service bulletin

Bulletin No. 2002-14
OEM No. 2002-04

Uneven or Increased Handle Effort After Control Installation – Commander 3000 Classic Panel Mount Remote Control

Misaligned Condition

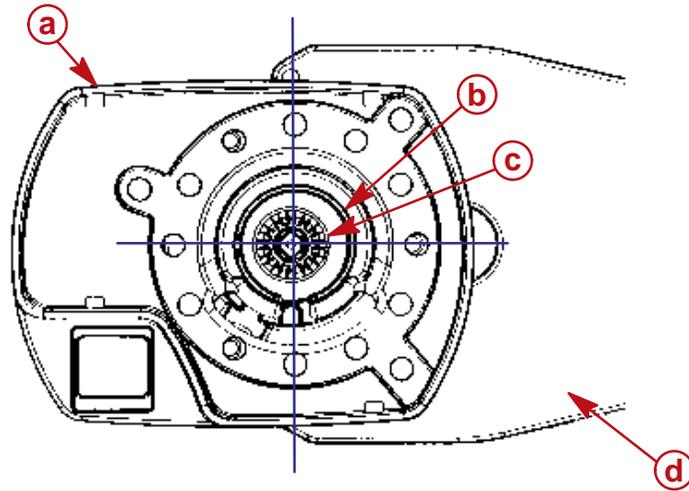
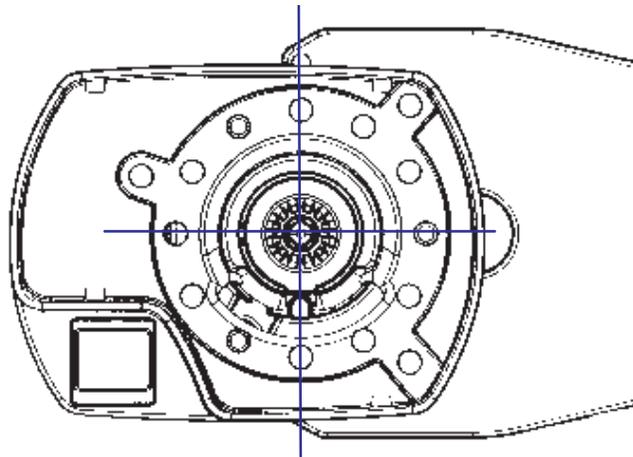
If the amount of effort required to shift the control handle of an affected Commander 3000 panel mount control seems high or feels uneven (easier to shift from neutral to forward or from neutral to reverse and then harder in the opposite direction), the control's bezel may have been misaligned during installation. This condition may be caused by tightening the remote control module to the bezel plate with the remote control handle shaft not properly centered in the bezel plate hub opening. This may occur if the handle is placed into the bushing and bezel opening with the brass handle retaining nut tightened to 17 Nm (150 lb-in.). The handle hub may then rotate in a slightly non-concentric manner, causing the handle to drag or bind in one direction but not the other. If this misalignment condition is extreme, the handle may feel tight in both directions.

- a** - Bezel
- b** - Handle Hub Opening
- c** - Handle
- d** - Remote Control Module

Properly Aligned

a - Control Handle Friction Screw Location

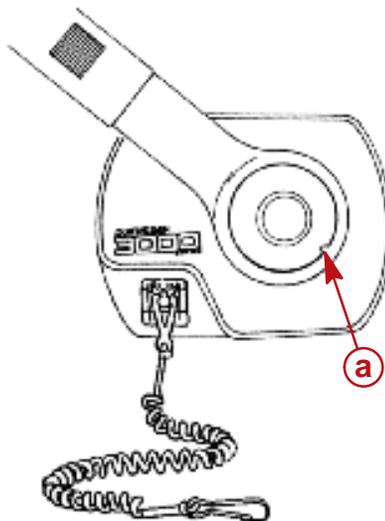
NOTE: Verify that the control handle friction screw located on the hub of the bezel plate is backed off before checking for this condition.

With the shift and throttle cables disconnected from the engine end, rotate the shift/throttle handle to the full throttle positions (both forward and reverse), feeling for handle rotation that is even in both directions. If the handle effort is higher in one direction over the other, remove the throttle only button and the handle nut. Pull off the control handle then remove the bezel cover plate. It is not necessary to remove the trim wiring, just pull the handle assembly out from the bezel and leave the wiring connected.

- a** - Mounting Screws (3)
- b** - Bezel
- c** - Remote Control Handle

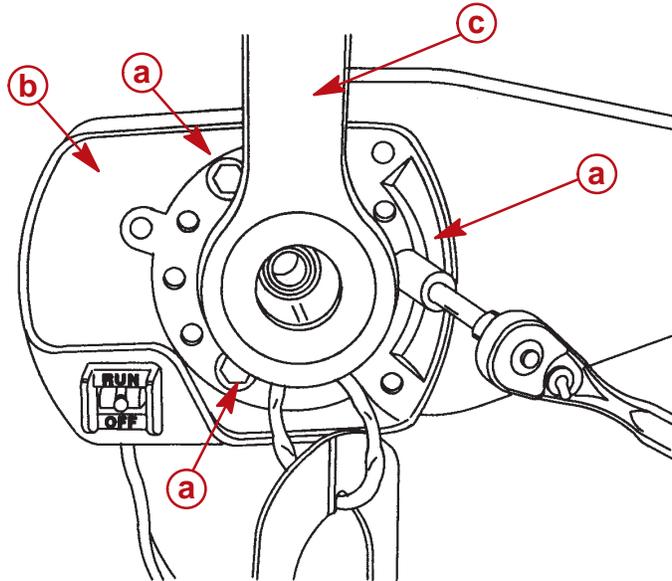
Loosen the (3) 1/4-20 screws securing the module assembly to the bezel plate just enough to allow for module free movement.

Pull the trim switch harness out far enough to allow slack and let the bezel cover plate hang.

Place the handle hub bushing back into position in the bezel plate opening. Using the handle hub as a centering tool, and with the bezel plate cover out of the way, push the handle hub in firmly towards the module letting the module align itself with the bezel plate. Using a ¼ in. drive 7/16 in. deep well socket and a short extension, begin tightening one or two of the 1/4-20 screws just enough to loosely draw the module up to the bezel plate while rotating the handle back and fourth several times, allowing the module to center itself into position.

a - Duct Tape

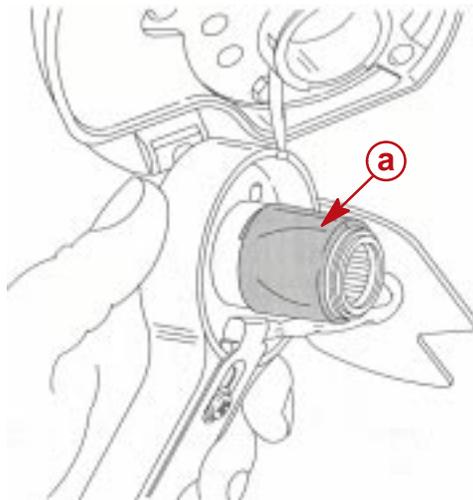
Wrapping a temporary piece of duct tape around the handle hub two times will help center the module to the bezel opening even quicker and may not require rotation of the handle. If used, don't forget to remove the tape before securing the handle to the module for the final assembly.

Remove the handle assembly and finish tightening the (3) 1/4-20 screws securely. Install the bezel cover plate and handle assembly back into position. Place a small drop of Loctite 271 (only needed if the original locking material seal was broken) onto the brass handle nut threads and tighten to 17 Nm (150 lb-in.). This procedure should help improve the component alignment and reduce or even out the normal handle friction rate. The handle should now rotate in both directions with the same amount of effort. Reconnect the throttle and shift cables at the engine end.
